# **The Shah Residence 424 South Columbia**

The City of Bexley, Ohio  
Board of Zoning and Planning  
Request for Certificate of Appropriateness

January 28, 2021

# Windows

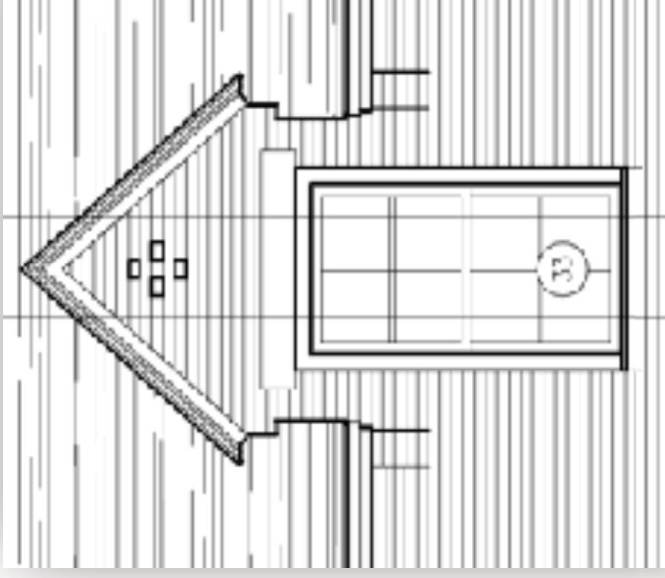
- 6 pane grid on top

- 4 over 4 panes

# Height

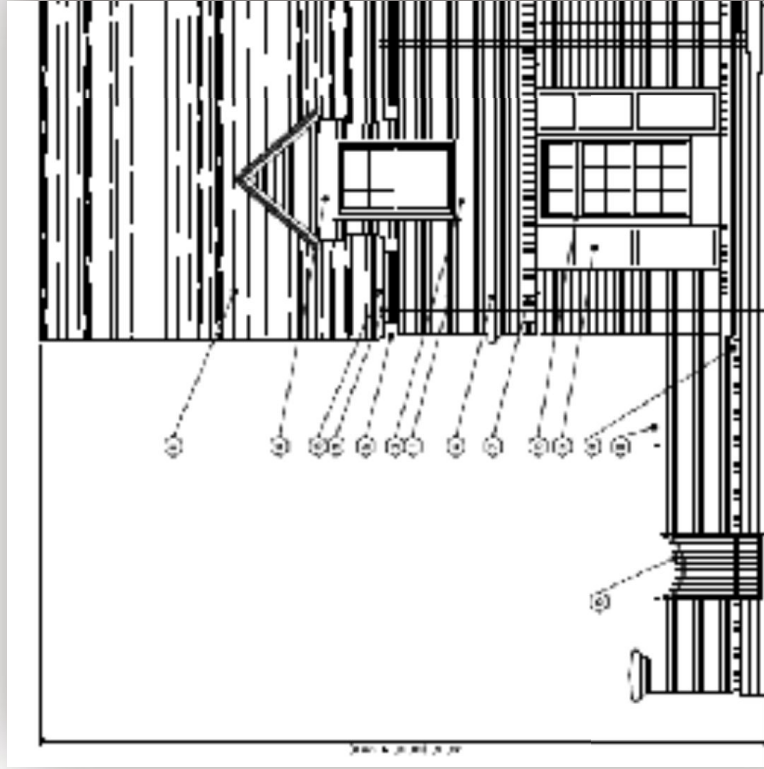
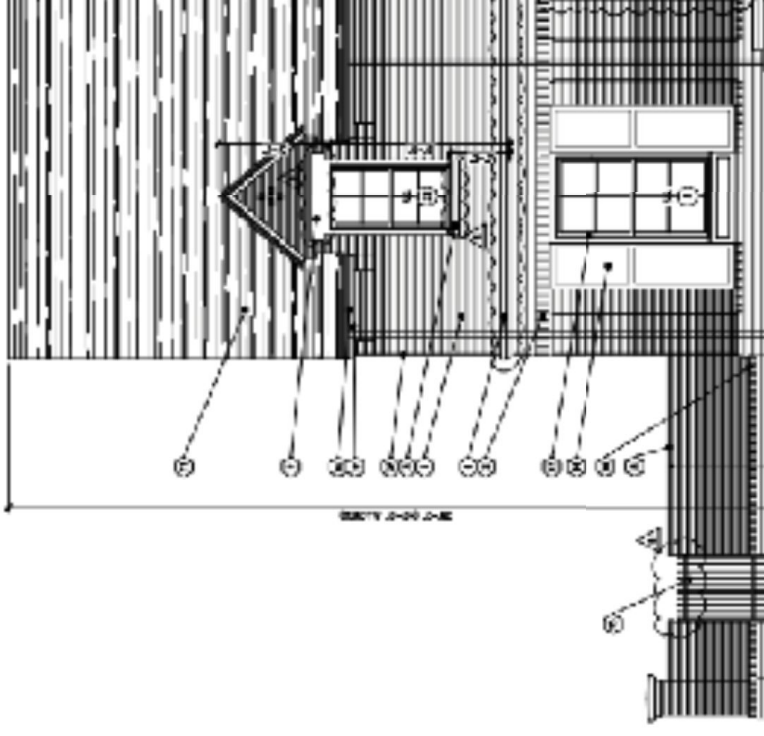
- 36'-6"

- Surveyed at 38'-0"

\*Code permits 40'-0"

# Garage Door

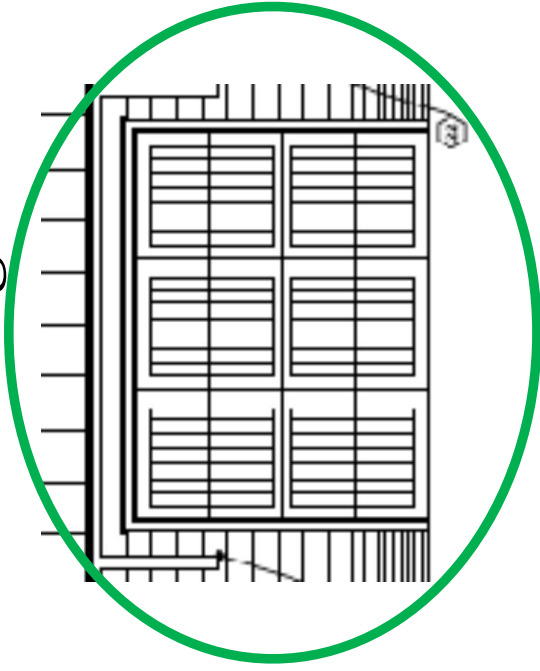
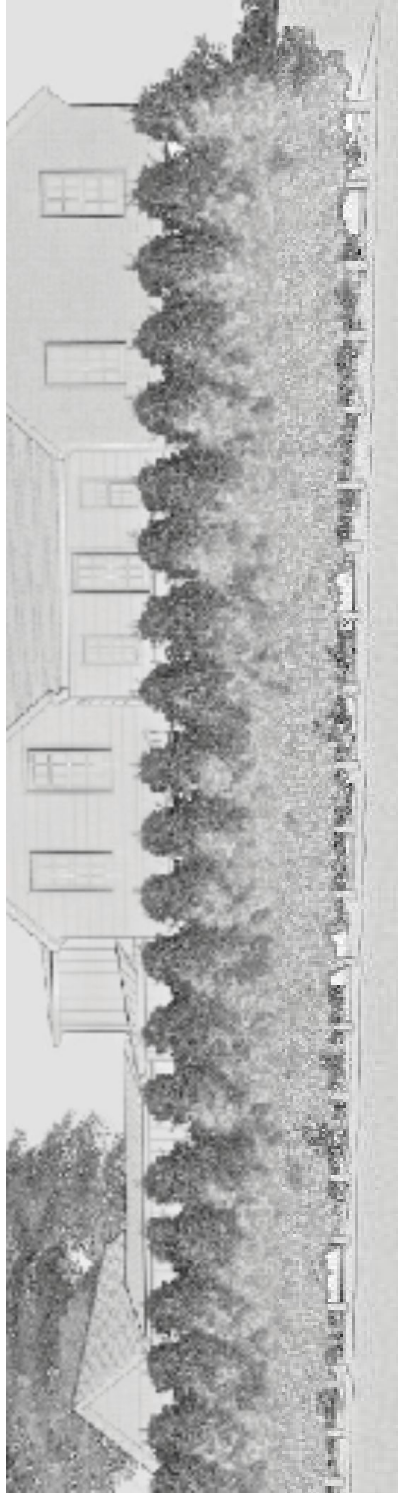
Limited visibility (if any) due to landscaping wall and hedges

# Skylights

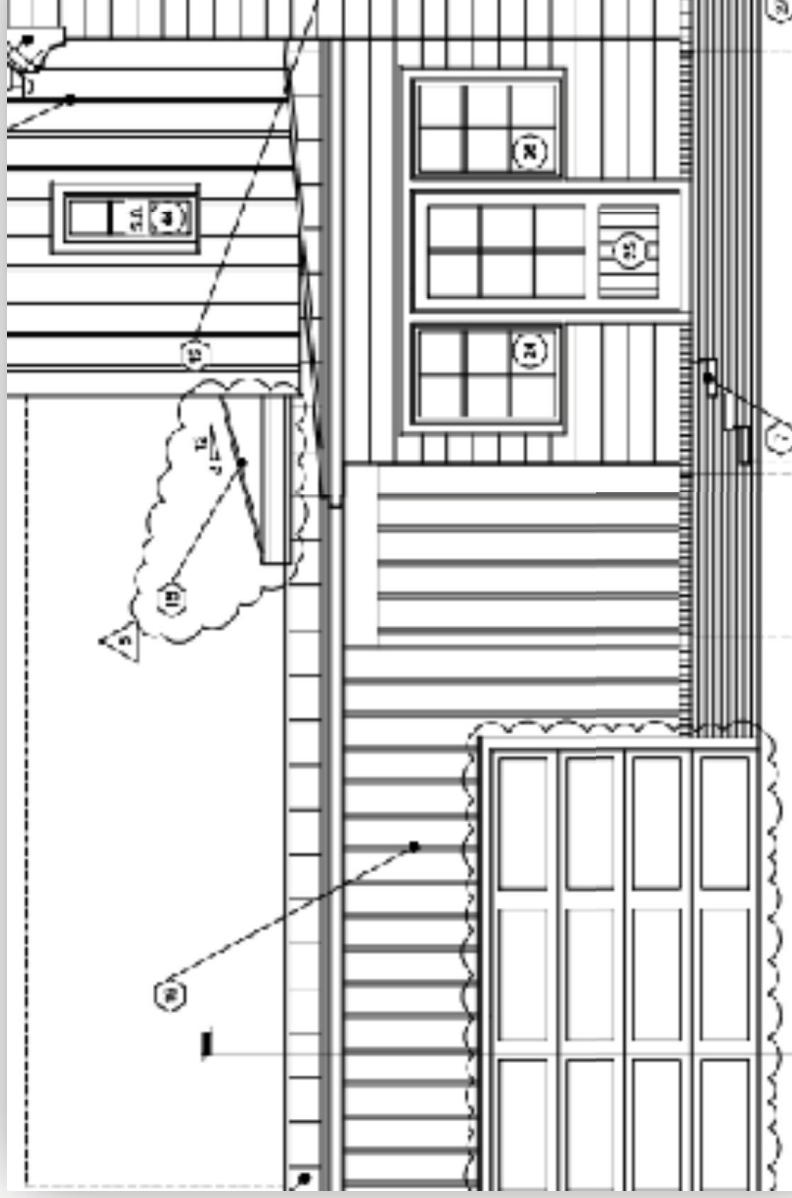
Limited visibility (if any)

# Other Issues

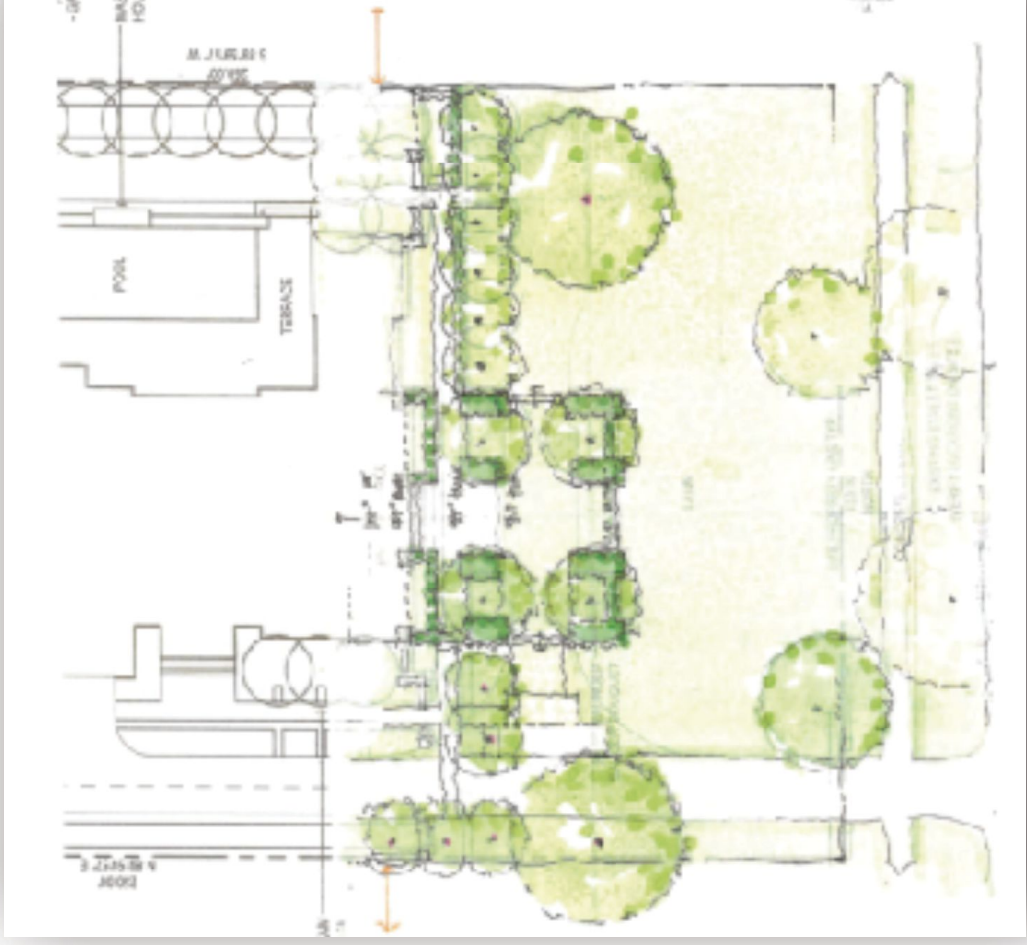
- Pool house: change in ridge line approved by staff
- Grade: recent survey shows that grade is as-approved
- Solar panels will be placed on flat roof
- Brick lintels are being corrected by Sullivan Builders to comply with 2018 plans
